Address: 234-36 S 8TH ST

Proposal: Legalize windows Review Requested: Final Approval Owner: Christina Chung and Jeffrey George Applicant: Don Munera History: 1810; Mills House; Robert Mills; moved from 9th and Locust to 8th Street, 1978 Individual Designation: 2/22/1978 District Designation: Washington Square West Historic District, Significant, 9/12/2024 Staff Contact: Dan Shachar-Krasnoff, Daniel.shachar-krasnoff@phila.gov

OVERVIEW: This application proposes to legalize five, first-floor windows on the Locust Street (north) façade that were replaced in February 2025 without the Historical Commission's approval. The Department of Licenses and Inspections issued a violation for the unpermitted windows. The replacement windows are incompatible with this historic building in style and material.

Figure 5. 234-36 S. 8th Street. Original window example.

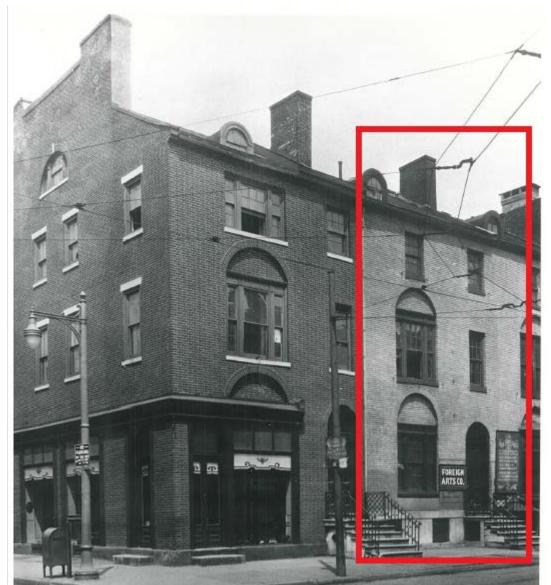
- The wood windows were replaced with vinyl windows that have interior muntins. The replacements windows do not replicate the historic windows in design, configuration, or material.

- The removed windows date from ca. 1980 when the house was moved, and brick cladding was added to the street-visible north façade. The north façade window openings were based on the openings in the associated building at 230 S. 9th Street. The replacement windows should be compatible with those on the primary façade facing 8th Street; therefore, the new windows do not meet Standard 6.

STAFF RECOMMENDATION: Denial, pursuant to Standard 6.
